Subject: **Robbins Mill Estates – Modification to Detention Basin #3**

Re: Modification to Detention Basin #3 – Robbins Mill Estates

DETENTION BASIN
PLANTING PLAN AND PLANT LIST
PROPOSED CONDITIONS PLAN
ROBBINS MILL ESTATES
ACTON, MA

RIP - RAP APRON

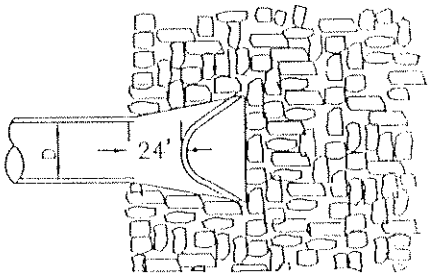
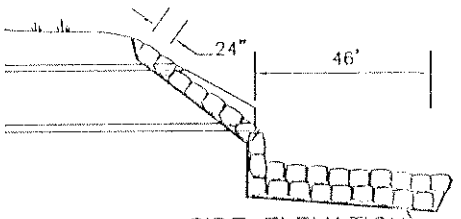
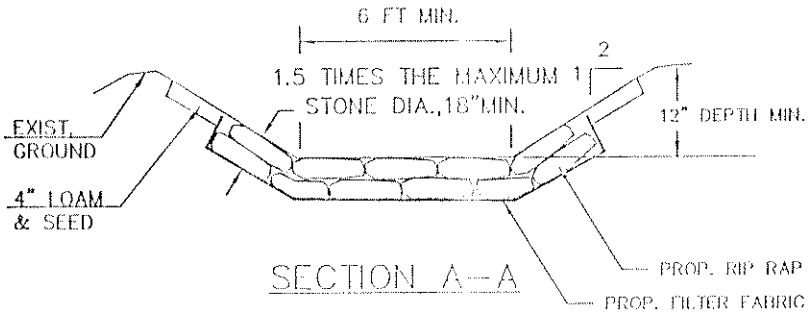
After almost fully completing detention basin #3, it became obvious that the size of the rip rap apron, at the inlet to the basin, was not designed large enough to effectively reduce scouring at the end of the pipe. To eliminate future scouring, we are proposing to enlarge the rip rap apron (see detail enclosed). By enlarging the apron, the plantings & the ground cover in the bottom of the basin will be altered/reduced. Also, upon closer review of the basin, the approved plans propose vegetation in some areas of the basin that will have difficulty surviving at the grades indicated on the plans. The plantings for the basin bottom have also been modified to be more appropriate for the proposed elevations specified on the approved plans. This change has been reviewed by the Conservation Department and is also being submitted to the Engineering Department. Enclosed are 3 copies of the plans describing the revisions. We believe that theses changes are consistent with the intent of the original design.

The storage capacity and the outflow from this detention basin will not be altered as a result of this work. We have reviewed the plan submitted with the request and found their proposal should rectify the erosion problem at the outlet pipe in the detention basin.

1 / BT-1 **DETENTION BASIN #3 LANDSCAPE PLAN**
SCALE 1"= 40'-0"

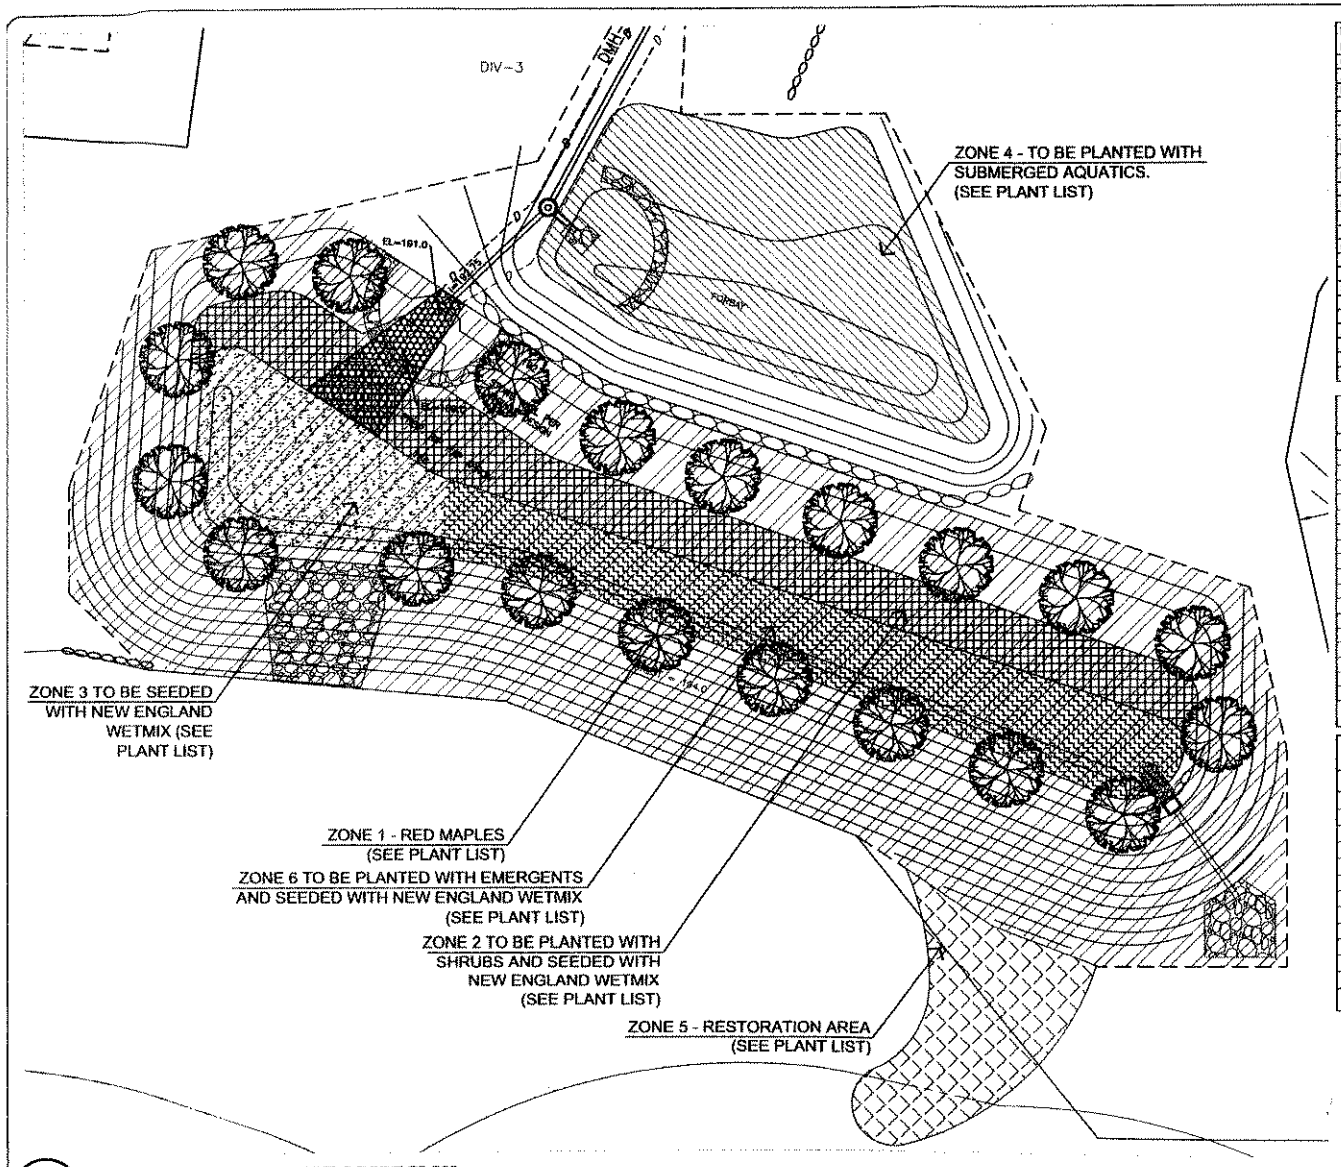
This office received a request from Marchionda & Associates dated October 11, 2006 to modify the design of detention basin #3. They are proposing to enlarge the rip rap splash pad at the outlet of the drain pipe and reconfigure the plantings & ground cover along the bottom of the basin.
